INDESIT company

Model type:
AMXXF149EU

Commercial code:
F037727

n1040398: Programme keys aligned.

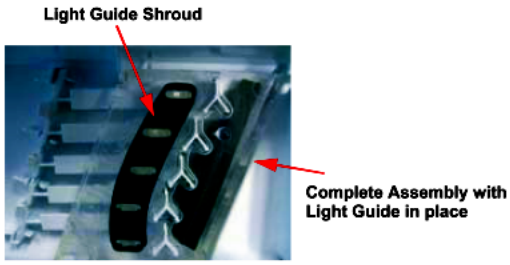
From serial no. 51118.0001, a specially shaped foam pad has been inserted between the keypad and light guide on washing machines AVXXF and AVXXL and washer-dryers AMFFX and AMXXL. The part code of this new component is C00142393 (fig. 001).

This new part separates the keys and pushes them outwards together to ensure they are perfectly aligned.

The pictures in figures 002 and 003 illustrate how the foam pad should be fitted on the keypad and subsequent assembly of the light guide with relative light guide bracket, code C00142648.

The new parts C00142393 and C00142648 can also be used on premodification appliances.

n0508c01: Door Gasket Clamp Band

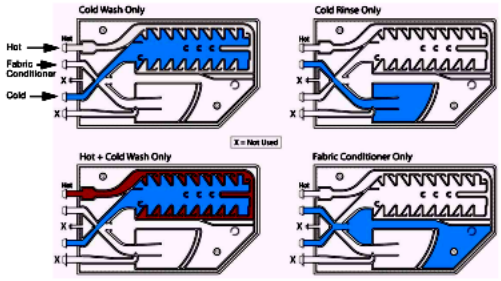
A New Polypropylene Gasket clamp band has been introduced in production from Serial number 80325.0000
The purpose is to provide added support to the inner rim of the door gasket.
